SERVICE 		1
		X 87.118-26

MODEL **281**

NEW DUST SEALING ON THE CLUTCH DRUM 50 15 980-02 WITH RIM SPROCKET

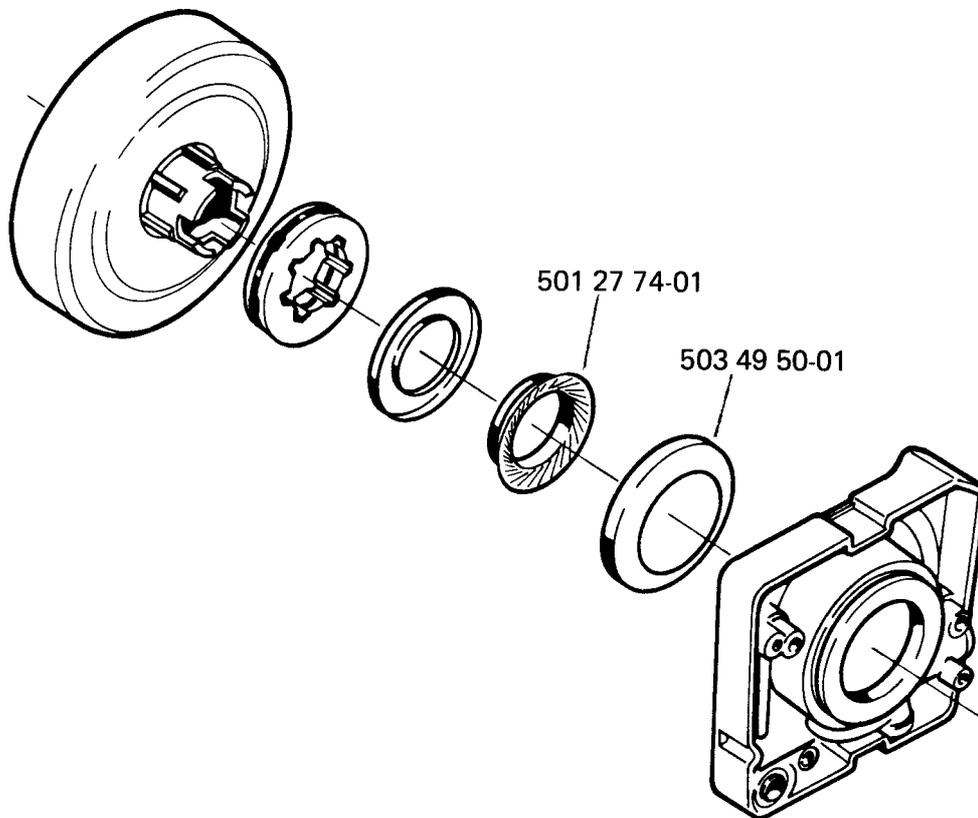
<u>New Ref. No.</u>	<u>Description</u>	<u>Excluded Ref. No.</u>
503 49 50-01	Dust sealing – oil pump	501 29 25-01
501 27 74-01	V-ring

The change was introduced from serial No. 6482940.
